# Beechcraft SERVICE BULLETIN

No. 63-4

Issued: September 20, 1963

**SUBJECT:** INSTALLATION OF IMPROVED THROTTLE AND MIXTURE CONTROL HOUSING CLAMPS, REINFORCEMENT OF ENGINE CONTROL MOUNTING BRACKET, AND CHANGE OF THROTTLE CONTROL RIGGING.

Figure 1

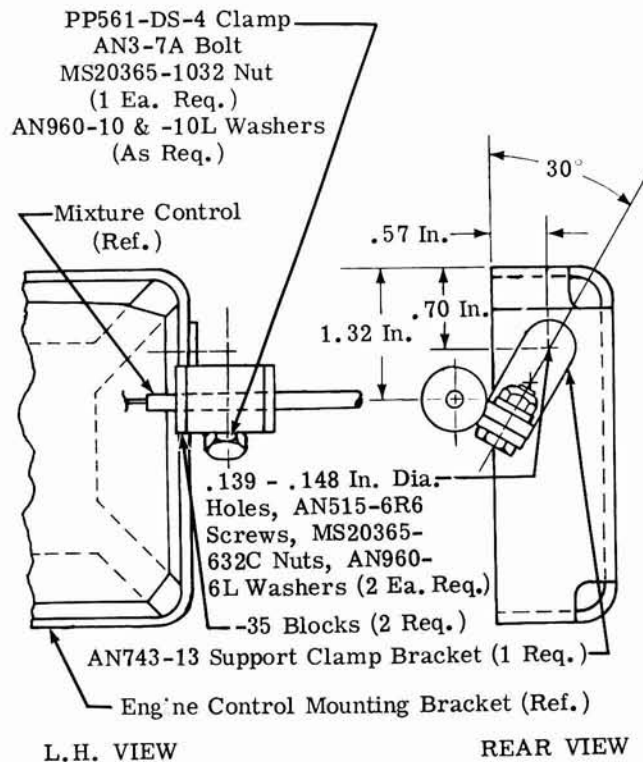
**DESCRIPTION OF CHANGE:** Part I consists of removing the existing mixture control housing clamp and securing the housing with a threaded phenolic block and steel clamp. Part II consists of rerigging the throttle control cable on the carburetor throttle arm. Part III consists of installing a reinforcing plate within the engine control mounting bracket and replacing the present throttle control housing clamp with a threaded phenolic block and steel clamp.

1. Remove the clamp and attaching parts securing the mixture control housing at the carburetor.
2. Position an AN743-13 support clamp bracket on the aft left hand side of the engine control mounting bracket as shown in Figure 1. Drill a .139 - .148 inch diameter hole in the engine control mounting bracket through the upper attaching hole in the AN743-13 bracket.
3. Attach the AN743-13 bracket to the engine control mounting bracket with an AN515-6R6 screw, MS20365-632C nut, and an AN960-6L washer. Do not tighten the

7. Secure the -35 blocks and the PP561-DS-4 clamp to the AN743-13 bracket with the AN3-7A bolt and an MS20365-1032 nut. Use AN960-10 and AN960-10L washers as required to obtain the 1.32 inch dimension shown in Figure 1.

Figure 2

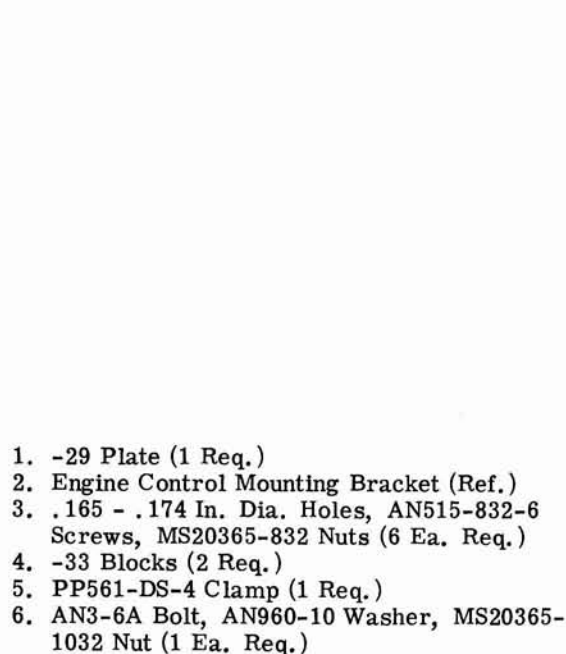
1. Remove the clamp and attaching parts securing the throttle control housing at the carburetor.
2. Position a 169-910002-29 plate (shown in Figure 2) over the outside edges of the engine control mounting bracket by aligning the .193 - .201 inch diameter hole in the plate with the corresponding hole in the bracket.
3. Bend the top and bottom edges of the -29 plate as necessary for a good fit within the bracket and drill six .165 - .174 inch diameter holes in the bracket through the holes in the plate.
4. Position the -29 plate within the bracket as shown in Figure 2 and secure the plate to the bracket with six AN515-832-6 screws and six MS20365-832 nuts.
5. Place two -33 blocks around the throttle control housing. Secure the blocks at the .193 - .201 inch diameter hole in the engine control mounting bracket with a PP561-DS-4 clamp, AN3-6A bolt, AN960-10 washer, and an MS20365-1032 nut.
